**CITY OF ROCKVILLE HISTORIC DISTRICT COMMISSION
STAFF REPORT**

**June 17, 2010
MEETING NO. 09-2010**

APPLICATION: HDC2010-00486B
ADDRESS: Pump House - 401 S. Horners Lane
ACCEPTED: June 1, 2010
45 DAY LIMIT: July 23, 2010
OWNER: Mayor and Council of Rockville
REQUEST: East window sash/louvered vent,
Landscape Plan, Interpretive
Feature location
STAFF: Robin D. Ziek

PROPOSED EAST ELEVATION - OPTION B

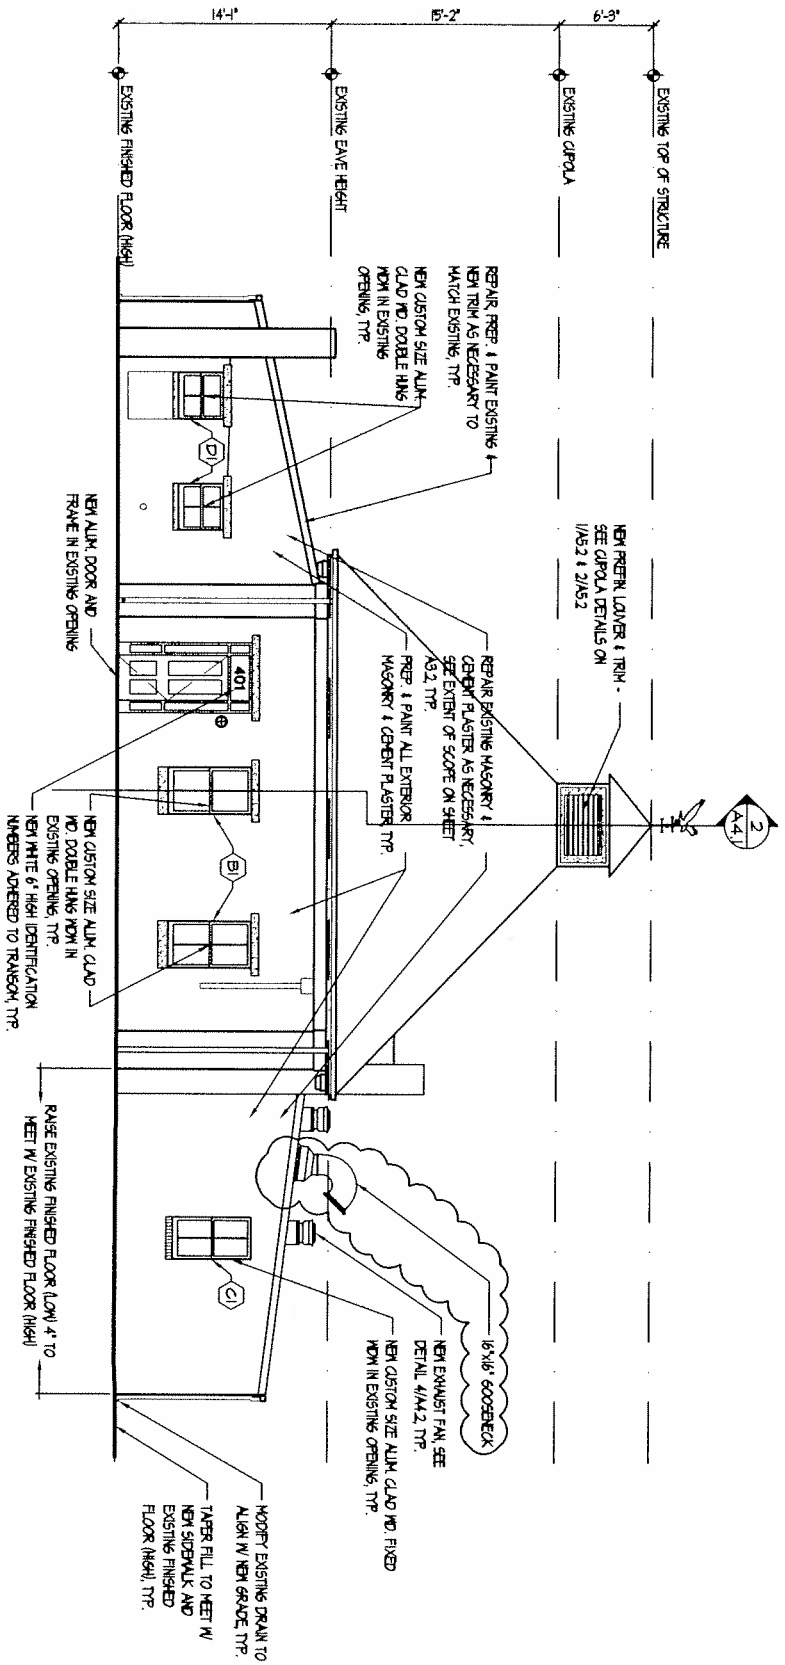
This leaves us with two options. As indicated in '(2010 05 17) 09-04 HDC A3.1A.pdf' (Option A), we can add a mullion to the louver above the window in question in order to give it the same appearance as the rest of the windows. – OR – The second option (Option B), as seen in '(2010 05 17) '09-04 HDC A3.1B.pdf', shows a 16" x 16" gooseneck duct. This would allow the window in the kiln room to have no louver.

Staff agrees that the proposed louvered sash is the simplest means of providing the required ventilation. Recognizing that the Pump House has been used for many different things over time, and that the kilns will likely be relocated at some point in the future, this will be the easiest alteration to retrofit to a 2/2 window, if so desired (see Circle 9-12).

1
A4.1 PARTIAL SECTION @ OFFICE CORRIDOR
SCALE: 1/2" = 1'-0"

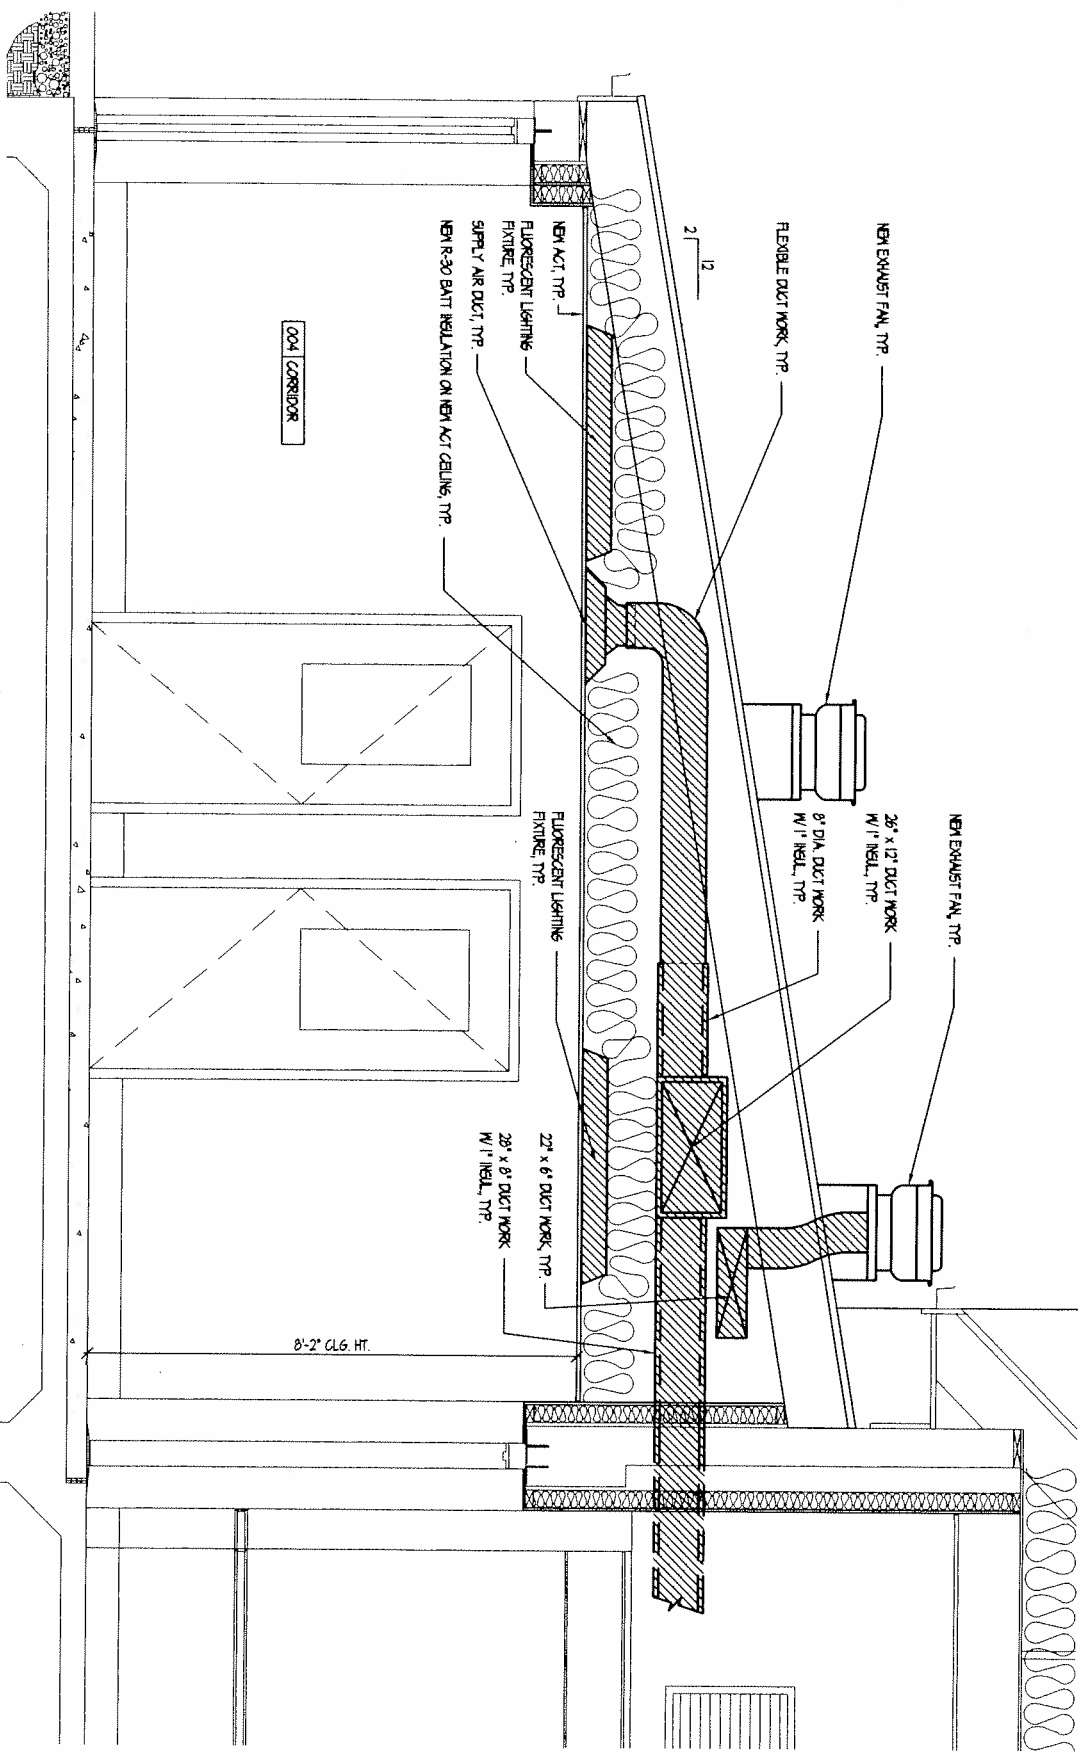
The applicant has investigated several different options to provide venting in this area, which will house electric kilns for the ceramics classes to be held here (see Circle 2-8). They determined that there was insufficient headroom for ductwork, to vent on the rear elevation; and they feel that the gooseneck vent on the roof would be obtrusive and problematic to remove if the kilns were relocated out of this area.

We sketched a partial section at the office corridor in order to determine the amount of space available for additional duct work. As you can see from the PDF titled '(2010 05 17) 09-04 HDC A4.1.pdf', we do not have enough room to route additional duct work through the office corridor and out through the back side of the building in lieu of the current louver / window configuration.

We sketched a partial section at the office corridor in order to determine the amount of space available for additional duct work. As you can see from the PDF titled '(2010 05 17) 09-04 HDC A4.1.pdf', we do not have enough room to route additional duct work through the office corridor and out through the back side of the building in lieu of the current louver / window configuration.

PROPOSED EAST ELEVATION - OPTION A

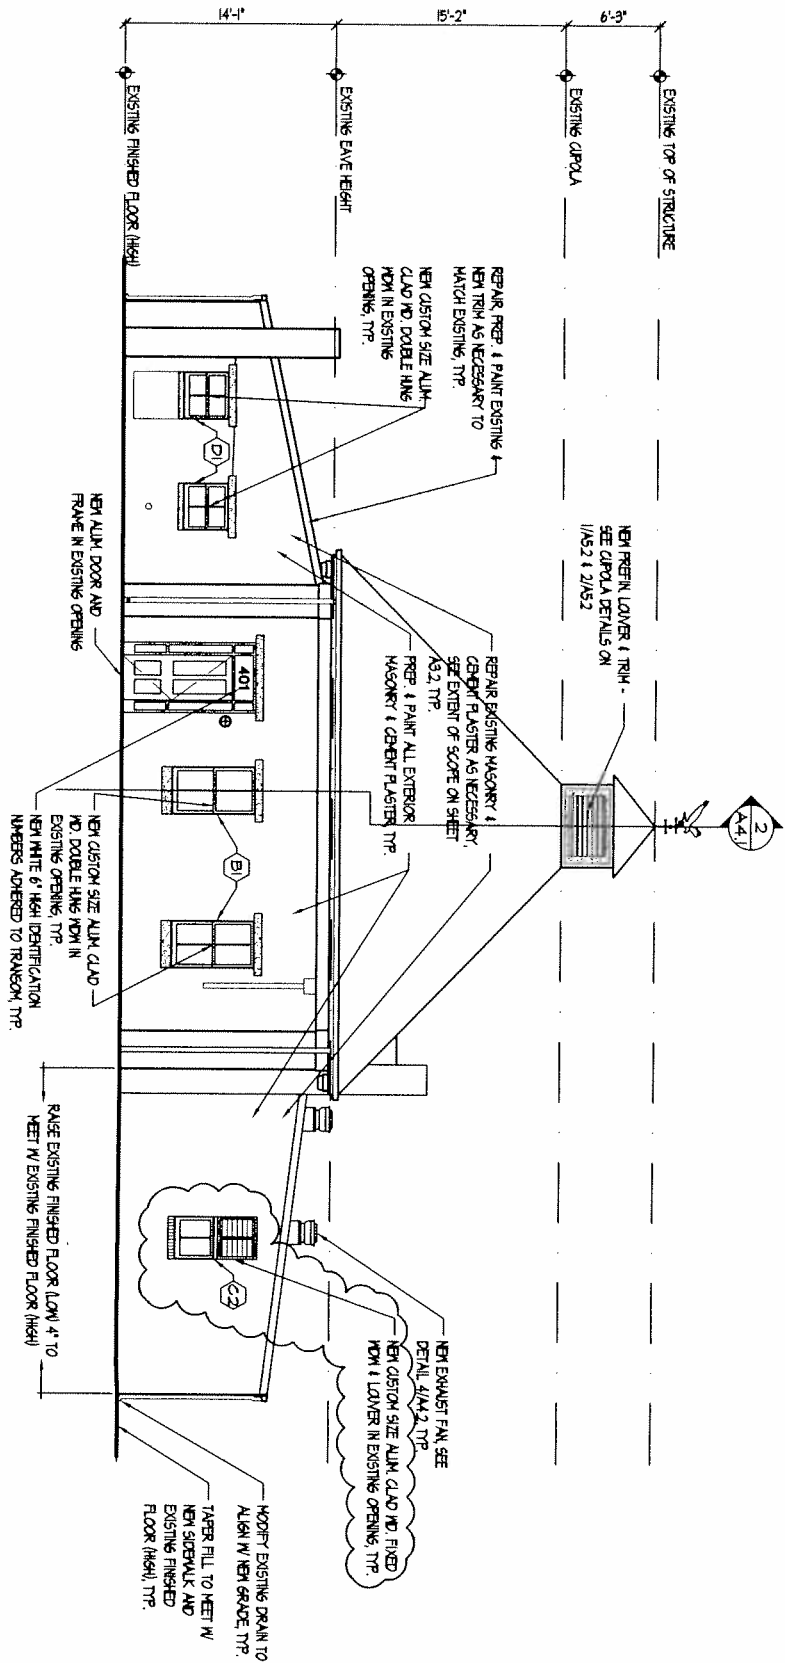
1) Review/approve installation of a louvered sash in the window on the east elevation of the concrete block north addition. The louver will be sized as a top 2-lite sash to balance the lower glazed sash, providing a 2/2 double-hung window configuration.

As indicated in '(2010 05 17) 09-04 HDC A3.1A.pdf' we can add a mullion to the louver above the window in question in order to give it the same appearance as the rest of the windows. The only other option would be a 16" x 16" gooseneck duct, which was not preferred by the HDC at their last meeting.
